Inspection of Automatic Sprinkler System

East London Industrial Development
Zone - Building HW1 - Ebor

UNC.9262

18.06.2024 10:39 SAST

Photo 3

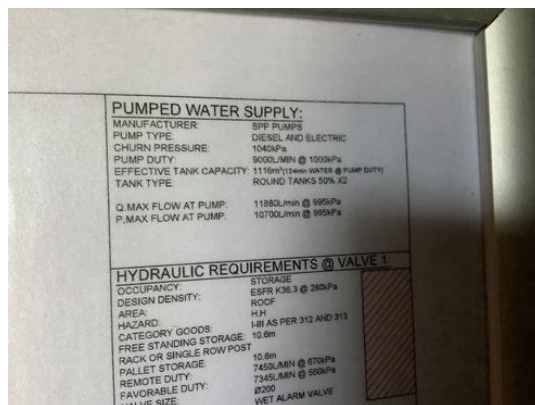
Photo 3

Photo 9

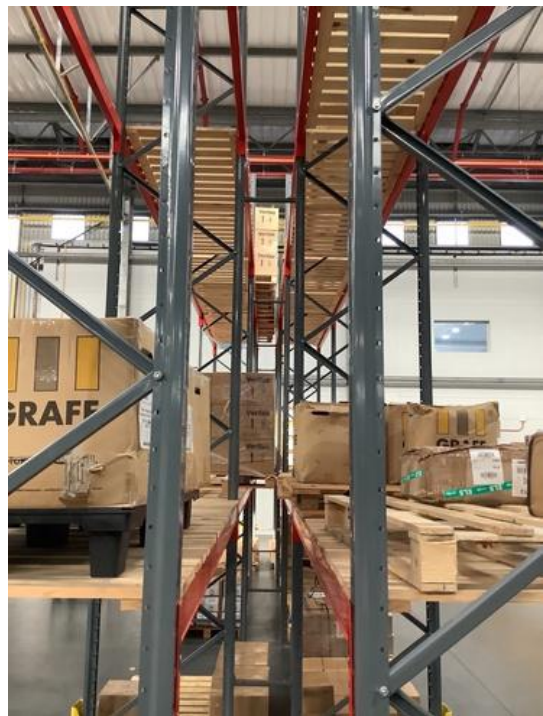
7.22 Trunk Main Pressure (kPa)

1160

7.23 Installation Pressure (kPa)

1380

The system pressure has exceeded the maximum allowable pressure of 1200 kPa, this must be investigated and rectified by your installer.
